**MEMORANDUM**

REVIEW TYPE: **Site Plan Review**
 CASE #: **820060100**
 PROJECT NAME: Loneoak Townes
 APPLYING FOR: Approval of six townhouses on 0.54 acres of land in the RT-12.5 Zone

Landscape Plan

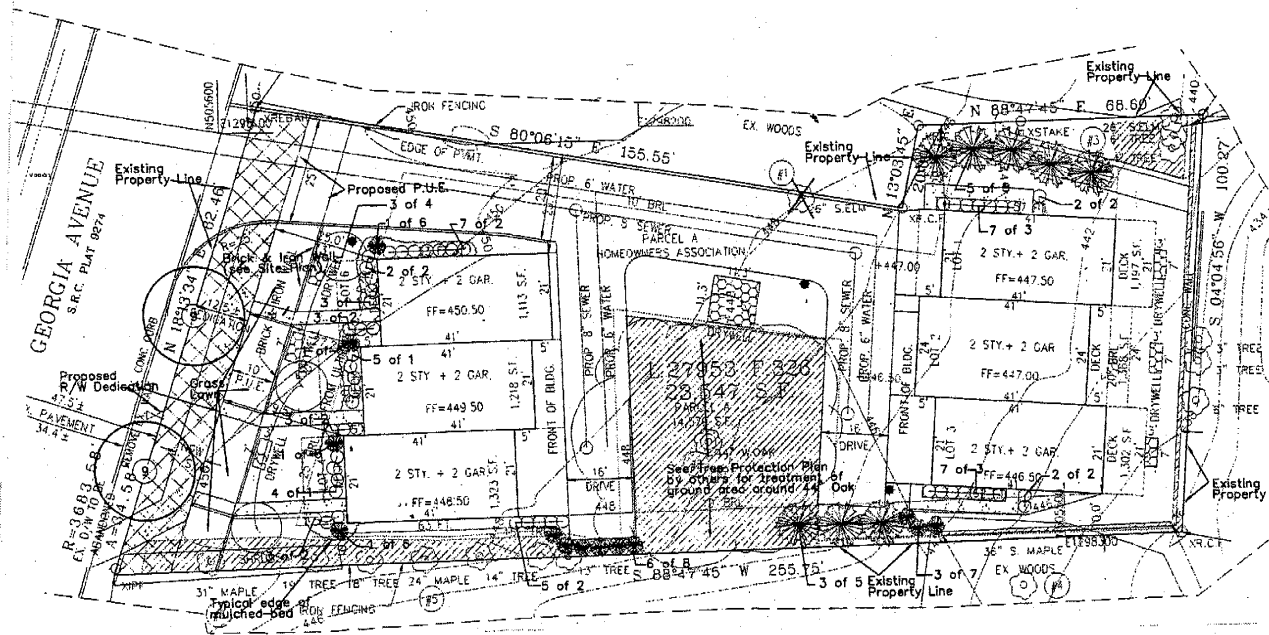
- a. Provide building setbacks and the ultimate right-of-way line on the site plan.
- b. The data table on the site plan shall be revised to match the data table in the staff report.
- c. The recreation table in the staff report shall be added to the site plan.
- d. Provide two benches (one sitting area) to meet the recreational demands on site.
- e. Provide the revised entry for Lot 3 on the landscape plan, lighting plan and the tree save plan.

Pedestrian connections are proposed from Georgia Avenue to the units facing Georgia Avenue and pedestrian connections are proposed from the driveway at the rear to the units in the rear. A condition of approval has been added to provide the width of the pedestrian connections.
